ADDENDUM No. 1
WOLF CREEK STREAM RESTORATION AT OREGON RECREATION COMPLEX

CITY OF OREGON
DEPARTMENT OF PUBLIC SERVICE

1) **Revised Plan Sheets 11, 12A, and 12B: Boardwalk Details**

1 / 12A BOARDWALK ELEVATION
NOT TO SCALE

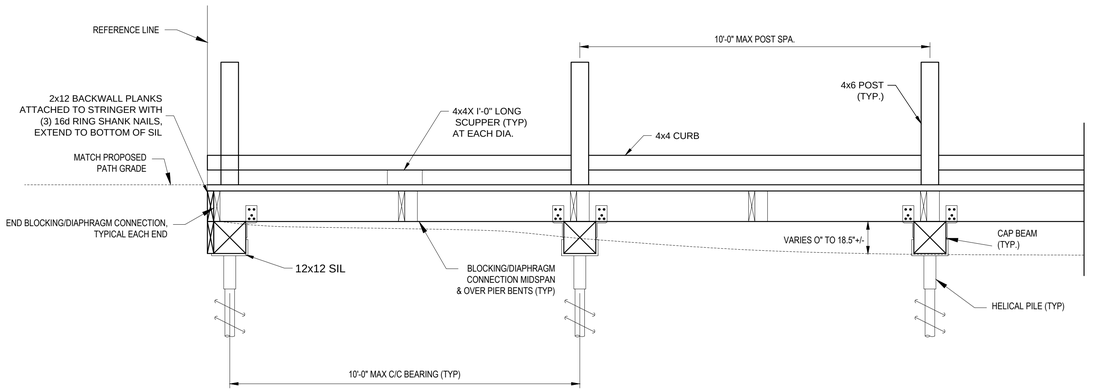
a) Drawings 11 12A 12B are not to scale. Even if the scale is corrected on Detail 1, Detail 2 that has the same scale is not the same. This is going to make it harder to give an accurate estimate.

RESPONSE:
   Drawings have been rescaled, scales now match.

3 / 12A TYPICAL SECTION
NOT TO SCALE

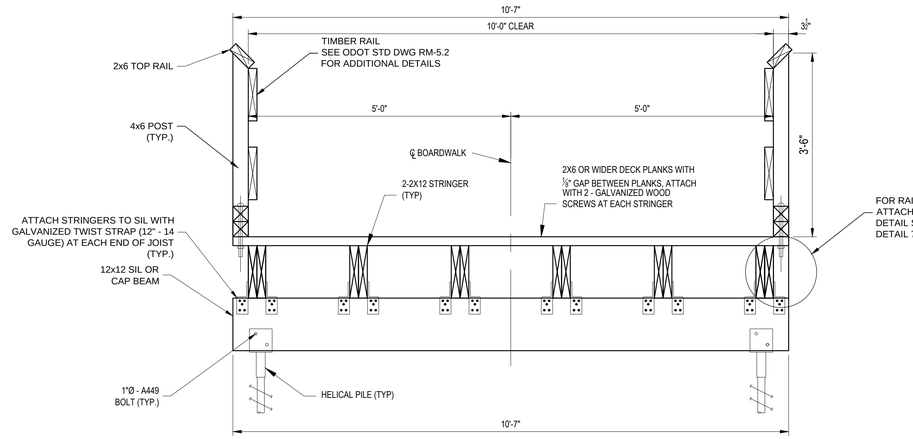
b) Detail 2 on both – show beams longer than the decking. Detail 3 shows flush with the decking. Verify which is correct.

d) Detail 3 on both – Specify type of twist straps as there are many different sizes and styles

e) Detail 3 both – Shows a Timber rail. No rail is shown on Detail 1 elevation to show post spacing.
   a. ODOT RM-5.2 dimensions will work with lumber dimensions given. This for bikeways not walkways. Curb is a 4x4 and post in RM-5.2 calls to be 6x6. Please note materials to use, where to install, and how the post are to be secured.

k) 3/12A is showing 2x12 double stringer and 6/12A is detailing a 2x8 double stringer. Will the 2x12 stringer need additional fastening for the additional width.

9) On drawing 12A, detail 3, we believe the scale is incorrect. Please verify it is correct.

10) Same drawing, the 2 x 12's shown in detail 3, appear to be shown as 2 x 8's in detail 5 & 6. Please clarify

13) Same drawing, detail 3, are the horizontal members 2 x 4's or 2 x 6's? ODOT has one thing, but drwgs do not match the odot spec….please advise.

The decking should be constructed as shown on Detail 3. The only instance decking may vary some is when the beams are offset for the next span. Decking extends to the end as shown on the detail.

RESPONSE:
12"-14 gauge for all connections.

RESPONSE:
The detail is for the horizontal rails. The post should be 6x4 and spaced at 10'-0" over each pier, 9'-0" spacing on the longer spans.

RESPONSE:
No. 6/12A should state 2x12.

RESPONSE:
Revised Drawing Issued. Scales have been removed, all dimensions are shown

Revised Drawing Issued. Scales have been removed, all dimensions are shown

Revised drawing issued...follow ODOT spec.

2 / 12A BOARDWALK PLAN
NOT TO SCALE

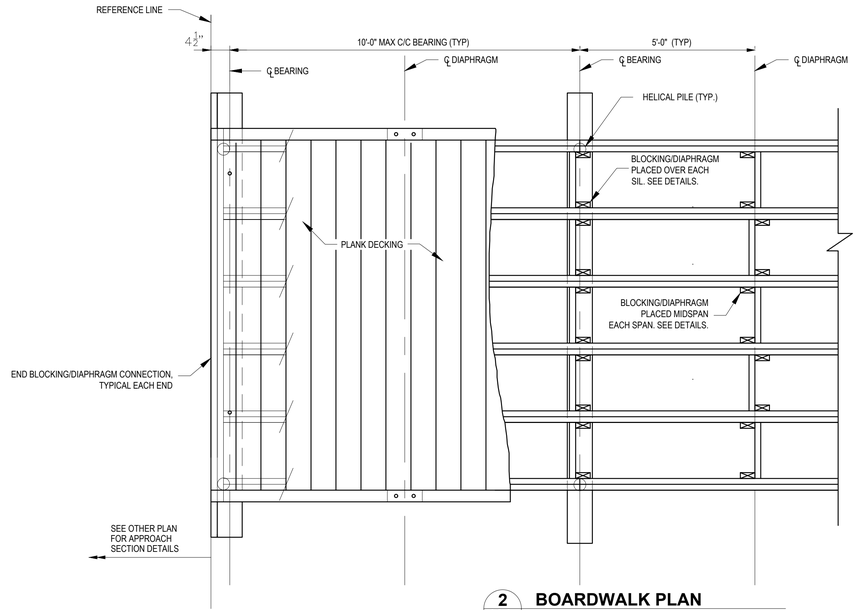
i) 2/12A – the way the joists are laid out on the overlap will not work with detail 3 & 4. Can the joists be staggered/overlapped at the cap beam and glued & screwed together?

RESPONSE:
Yes, shown as one line now on the drawing.

5 / 12A BLOCKING/DIAPHRAGM DETAIL
NOT TO SCALE

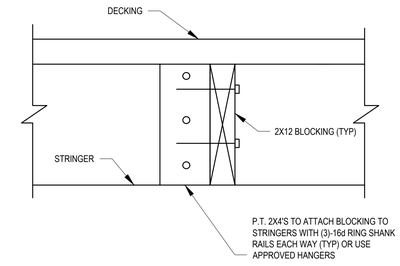
c) Detail 2 on both – seem to have something bolted on the inside on the double 2x8 on the left side. What is this?

RESPONSE:
We are assuming you are referring to Detail 5. It's a 2x4 to attach the diaphragm to.

1 / 12B BOARDWALK ELEVATION
NOT TO SCALE

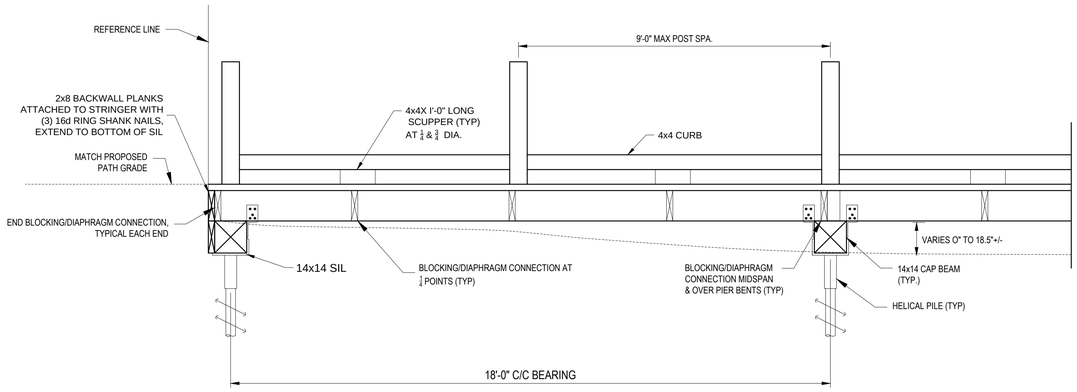
h) 1/12B appears to match detail 1/12A with 2x diaphragm. Detail 2/12B shows Glulam diaphragm. Confirm which is to be used.

RESPONSE:
Bolted 2x12

3 / 12B TYPICAL SECTION
NOT TO SCALE

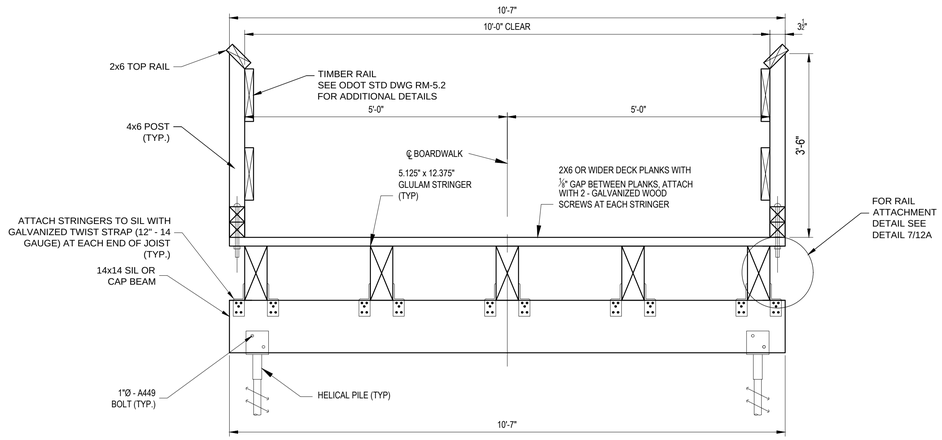
g) Dimension on the left 10'-0" Boardwalk path. Should this be 10'-7" per Detail 3?
RESPONSE:
Path is 10'-0" out to out is 10'-7".

2 / 12B BOARDWALK PLAN
NOT TO SCALE

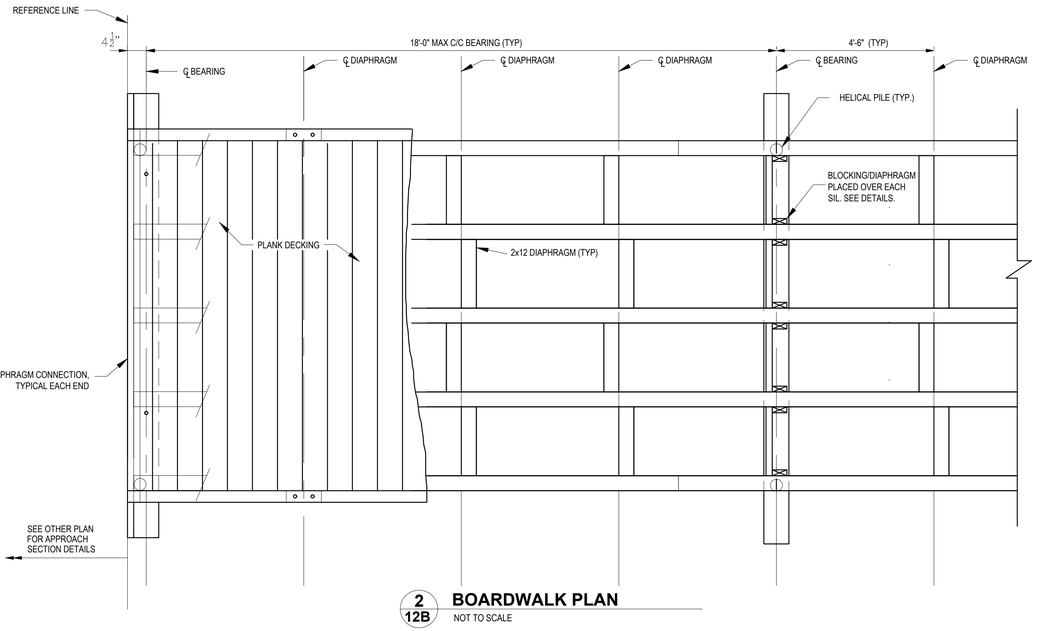
j) 2/12B – Where the section overlap on the cap beam (right hand side). Do the Glulam beam need to be doubled up for the second section? If so, what does the third section consist of if these 2 are different.

5) 2/12B – Do the threaded rod need to be 4.5' for a reason? That is over 12" to long for the boardwalk area.

6) 2/12B – Does the diaphragm blocking over the cap beam need to be similar to detail 5/12A? Does it need to be the full 12.375" of the Glulam or would 2x12 work?

RESPONSE:
Single is only needed.

RESPONSE:
No, dimension removed

RESPONSE:
No, and a 2x12 will work

4 / 12B OVERLOOK PLAN
NOT TO SCALE
STRINGERS TO BE CONNECTED TO BEAMS USING 12" - 14 GAUGE GALVANIZED TWIST STRAPS

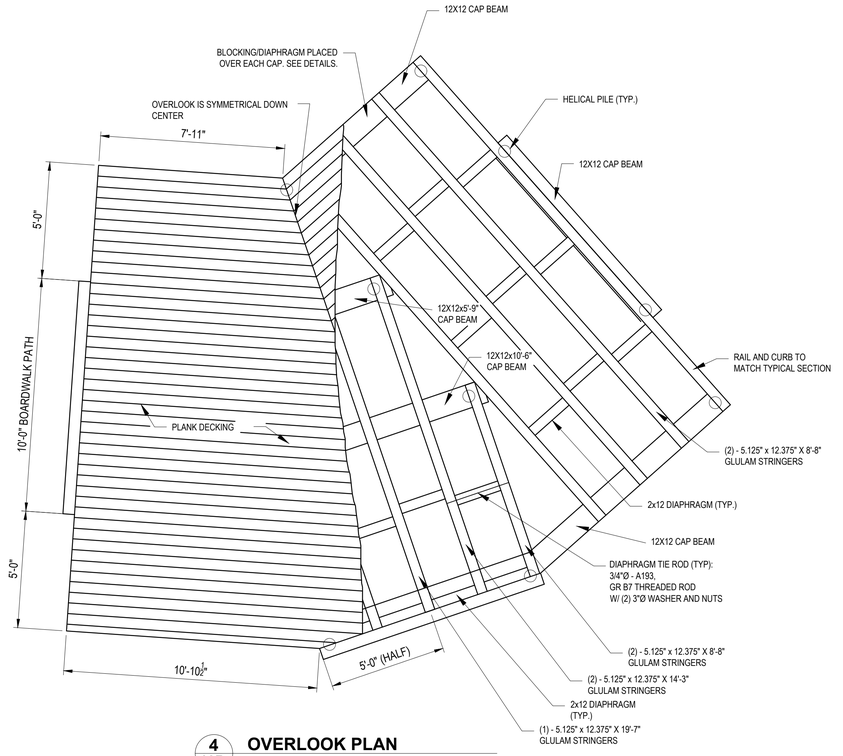
a) Are Glulams connected to the beams with the same twist straps?

c) What is to be used to catch the deck boards wear they land where the Glulams change direction (outside 45 degree corners)?

4) Overlook Plan – What is the dimension of the cap beam at the bottom of the detail that connects to the 18' sections? 12" or 14"?

RESPONSE:
Yes

RESPONSE:
Added a diaphragm to catch it.

RESPONSE:
14x14
